**1<sup>st</sup> Further Information**

**Proposed Temporary Warehouse (Excluding Dangerous Goods Godown) with Ancillary Facilities  
and Associated Filling of Land for a Period of 3 Years in "Agriculture" Zone,  
Lot 1452 (Part) in D.D. 107 and Adjoining Government Land, Fung Kat Heung, Yuen Long, N.T.**

**(S.16 Planning Application No. A/YL-KTN/1192)**

Responses-to-Comments

Title: Drainage Proposal - LAYOUT  
D01

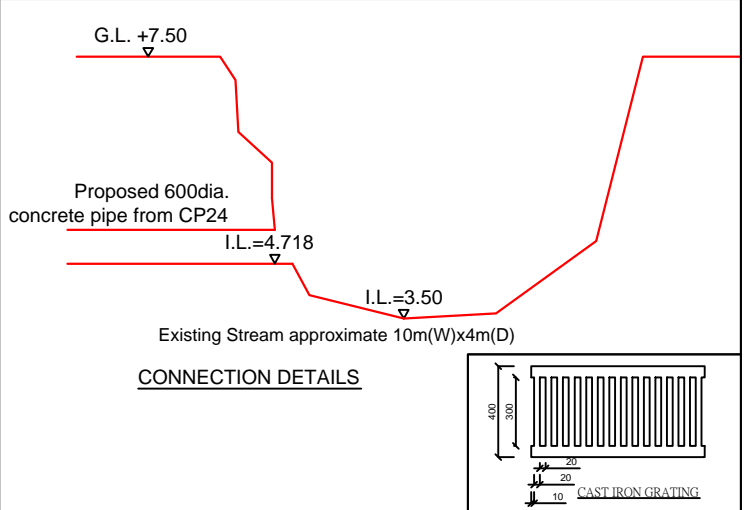
(2)	<p>The applicant should clarify discrepancies of sizes of existing surface channel and the proposed surface channel at the upstream of the proposed catchpit CP4 shown on the submitted</p>

(5)	Drawings (No. :D01 & D03): Peripheral surface channels shall be provided along the site boundary to collect the surface runoff accrued on the application site and to intercept the overland flow from the adjacent lands. It is noted that there is proposed land filling works for the development. Proper surface channels should be provided at the lower level/platform and wall tow to collect the overland flow to/from adjacent areas.

(A) Specific Comments		
(1)	<p>The applicant should clarify discrepancies of the proposed and existing ground levels of the application site shown in the submitted application form and drainage proposal.</p>	<p>Noted. The applicant has proposed a new scheme for the drainage arrangement. Please refer to the revised drainage proposal for details (<b>Annex I</b>).</p>

**Ultimate Discharge Path (Drawing: D01a)**

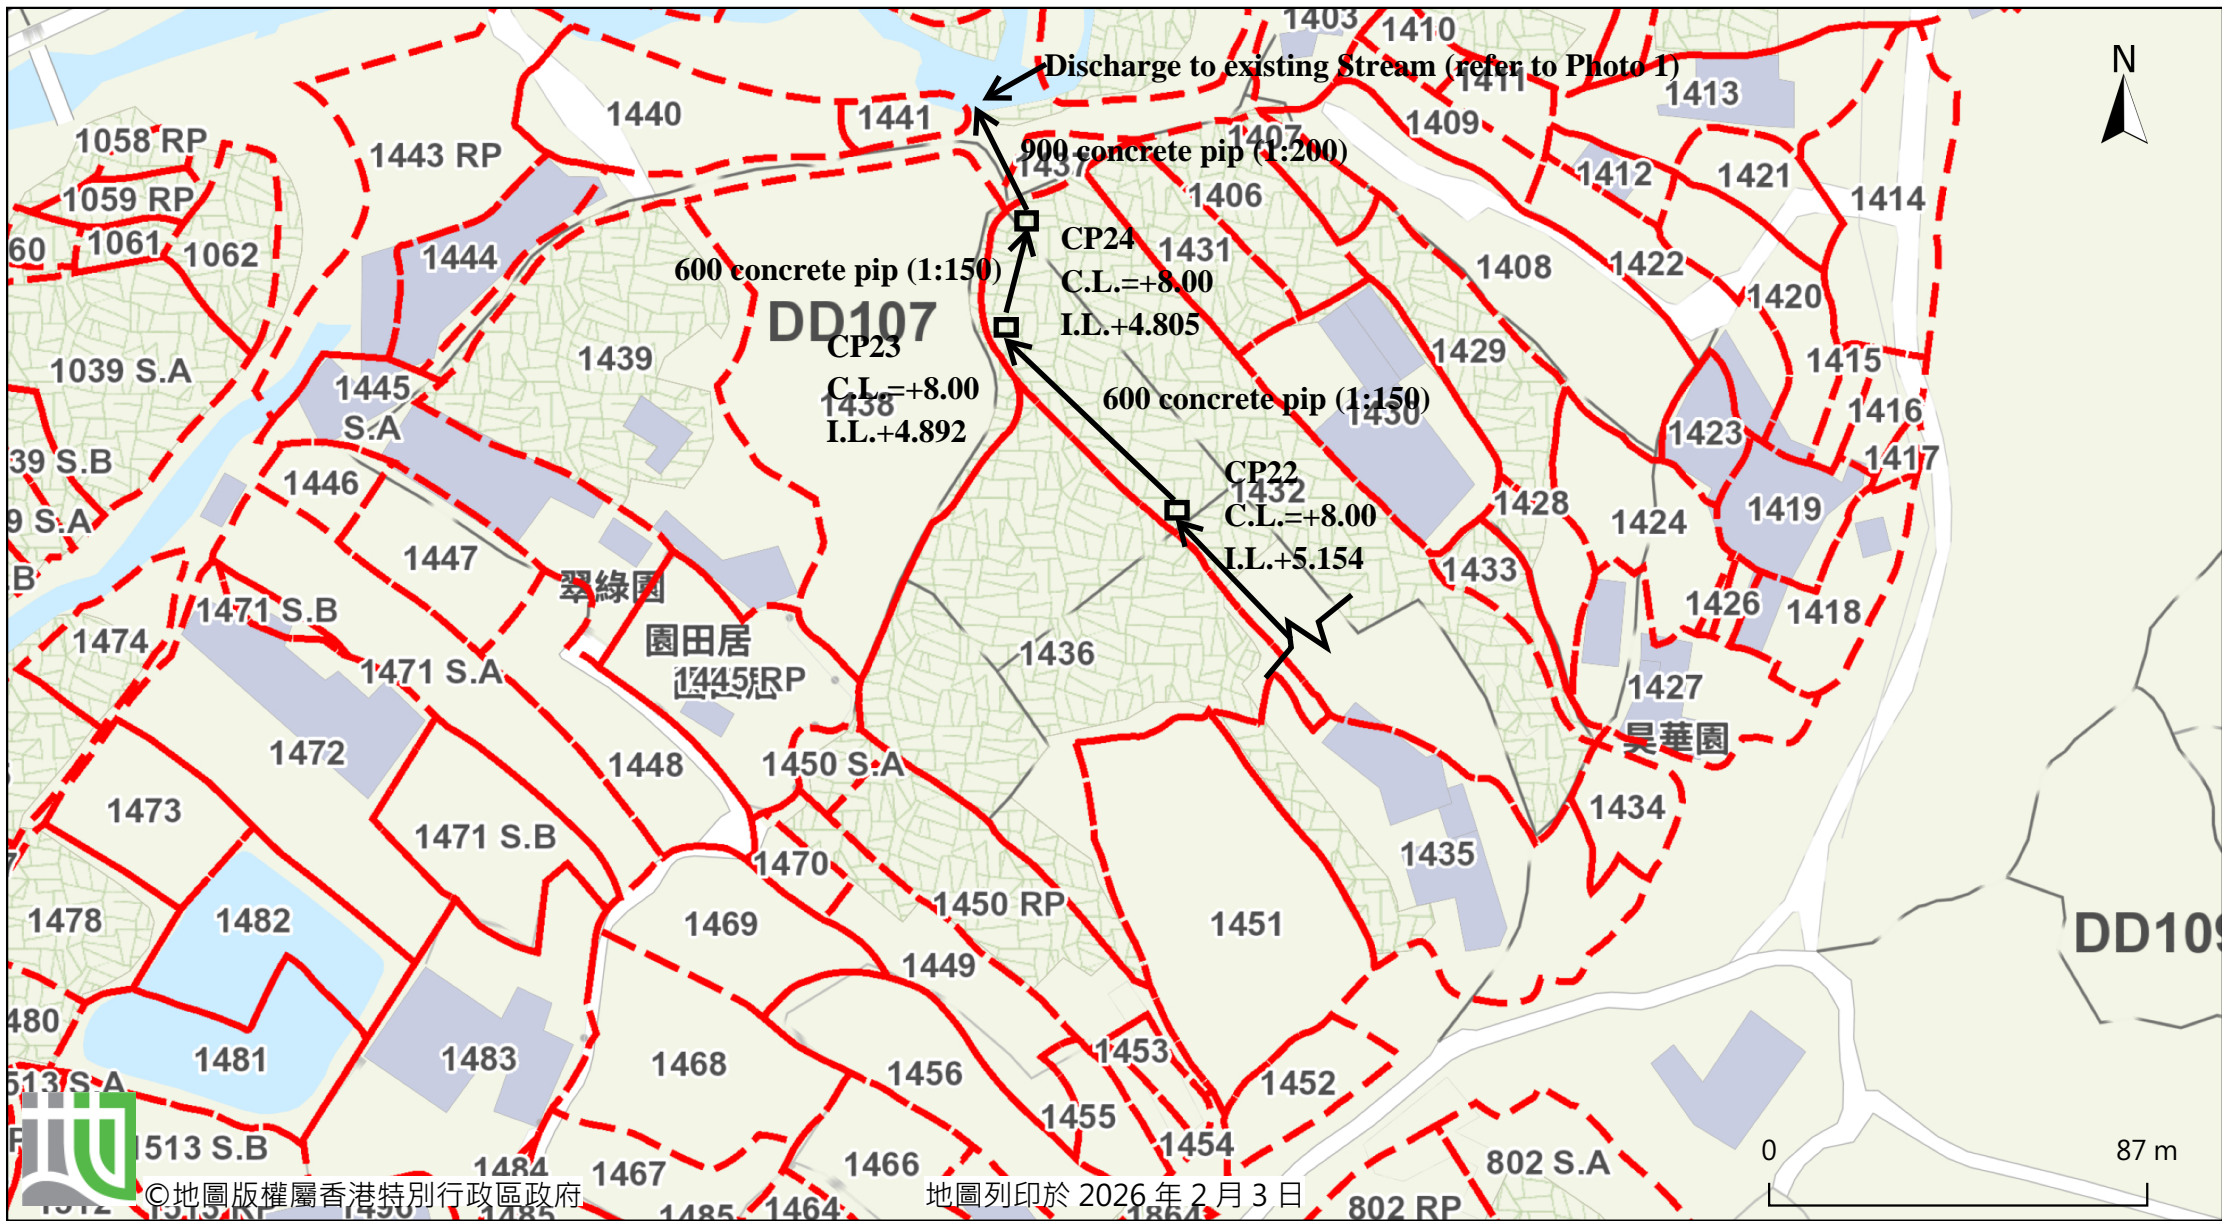
(6)	The applicant should clearly indicate the full alignment of the discharge path from the application site all the way down to the ultimate discharge point (e.g. a well-established stream course/public drainage system).

**Catchment Area Plan**

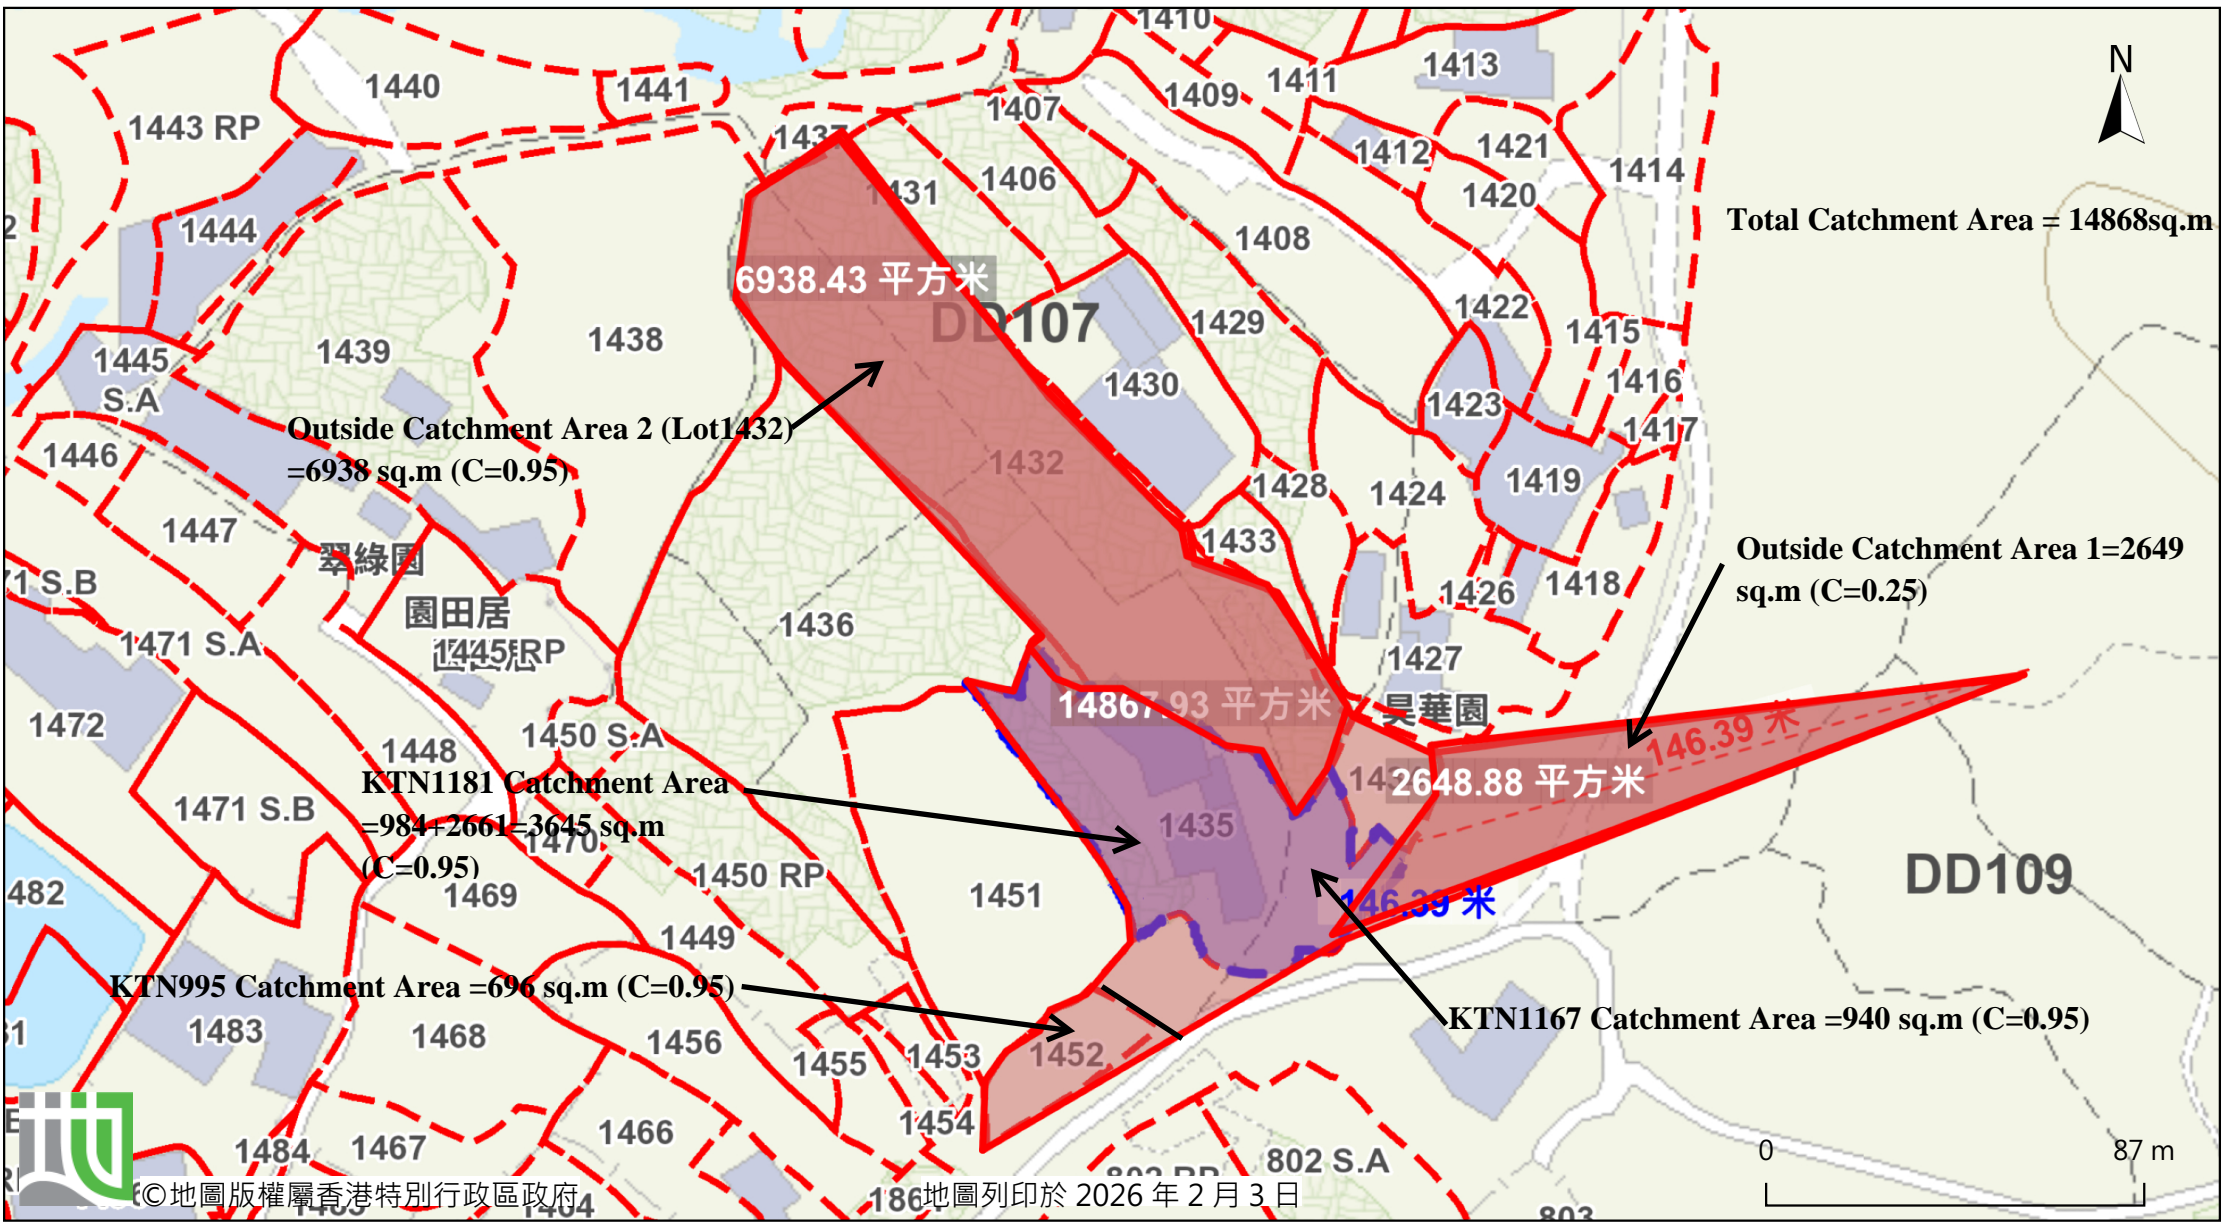
(4)	The ground to the northeast of the application site is generally higher. According to the topography around the subject site , external catchment shall be greater than the one adopted in the submitted hydraulic calculation. The applicant should update hydraulic calculation.

(8)	<p>The applicant should demonstrate with hydraulic calculation that the proposed drainage facilities are adequate to collect, convey and discharge the surface runoff accrued on the application site and the overland glow intercepted from the adjacent lands.</p>

1	Catchment Area for KTN995, Area	= 696	m <sup>2</sup>	(C= 0.95 )
2	Catchment Area for KTN1167, Area	= 940	m <sup>2</sup>	(C= 0.95 )
3	Catchment Area for KTN1181, Area	= 3645	m <sup>2</sup>	(C= 0.95 )
4	Outside Catchment Area 1, Area	= 2649	m <sup>2</sup>	(C= 0.25 )
5	Outside Catchment Area 2 (Lot1432), Area	= 6938	m <sup>2</sup>	(C= 0.95 )
	H	= 18.767		(H=(37-9.6)/146*100)
	L	= 146	m
